February 21, 2008
LIC-08-0015

SUBJECT: Response to Request for Additional Information Regarding License Amendment Request for Proposed Technical Specification Changes for Modification of Containment Spray System Actuation Logic

**RESPONSE TO REQUEST FOR ADDITIONAL INFORMATION
REGARDING LICENSE AMENDMENT REQUEST (LAR)
FOR PROPOSED TECHNICAL SPECIFICATION CHANGES FOR
MODIFICATION OF CONTAINMENT SPRAY SYSTEM ACTUATION LOGIC**

FORT CALHOUN STATION (FCS), UNIT NO. 1

TYPICAL SG PRESSURE CHANNEL
(BEFORE)

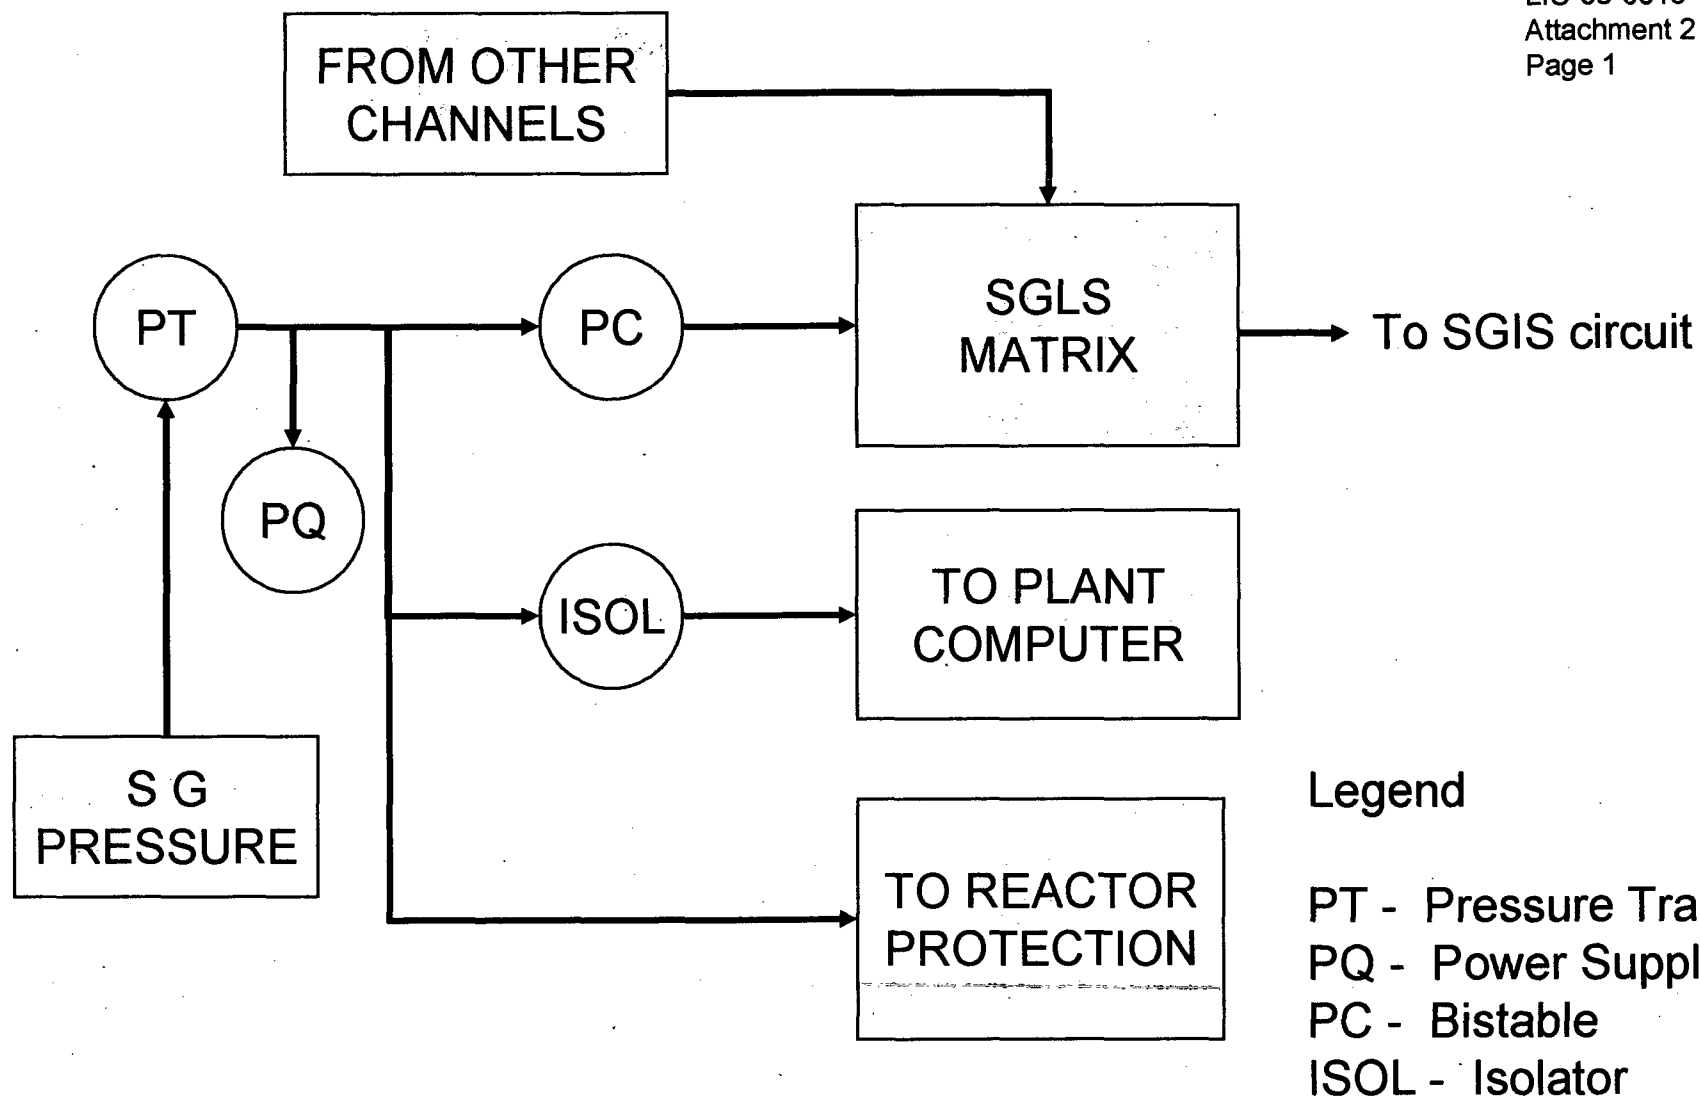
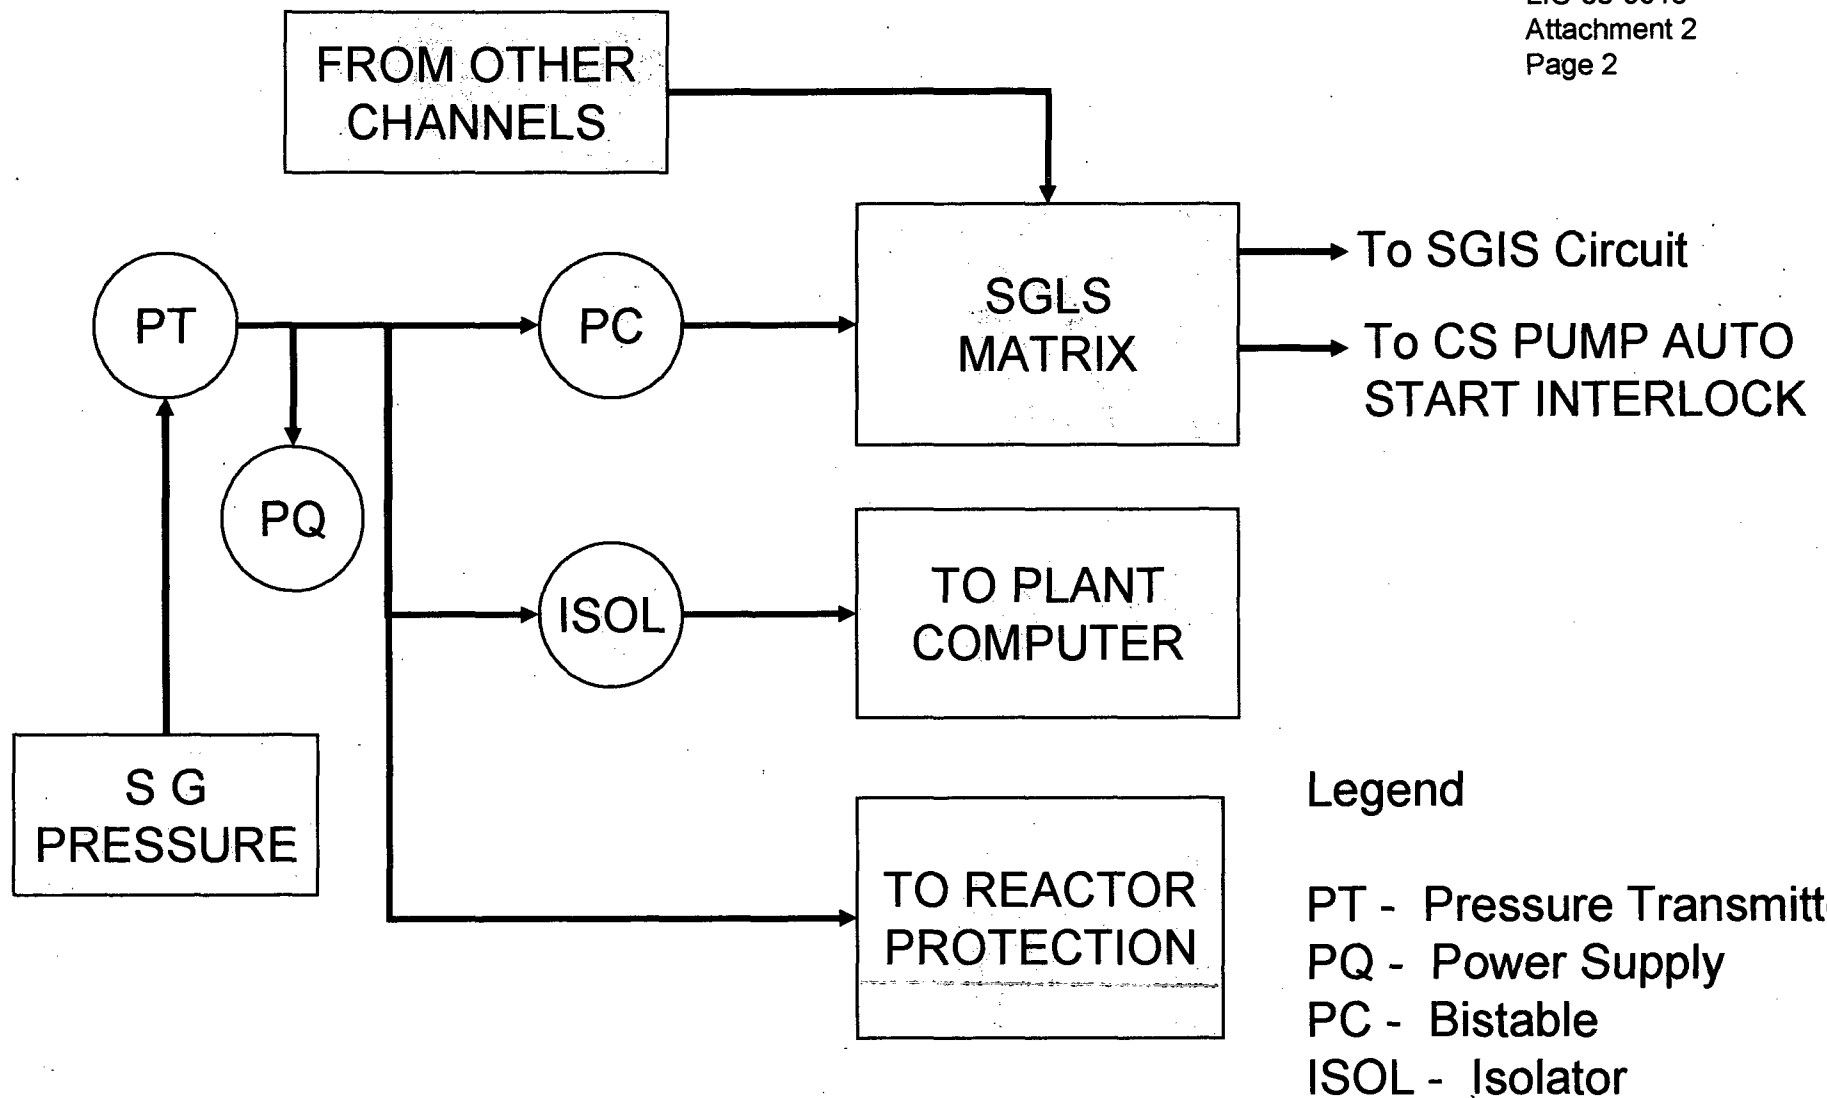
14. Regarding setpoint changes, please explain why the loop uncertainty for this new engineered safety features function has not been affected. Please provide diagrams and supporting discussion for the new containment spray actuation logic.

The SGLS signal used for the new interlock is taken from the SGLS logic matrix. This signal is derived from the same logic as the existing Steam Generator Isolation Signal (SGIS) contact output from the SGLS matrix (see Attachment 2, Pages 1 and 2). Because the interlock is taken from an existing contact output from the SGLS matrix, no analog components are affected and no new analog equipment has been added. The SGLS trip bi-stables and associated analog instrument loops are unaffected by this change. Thus, the loop uncertainty is not affected by this logic change.
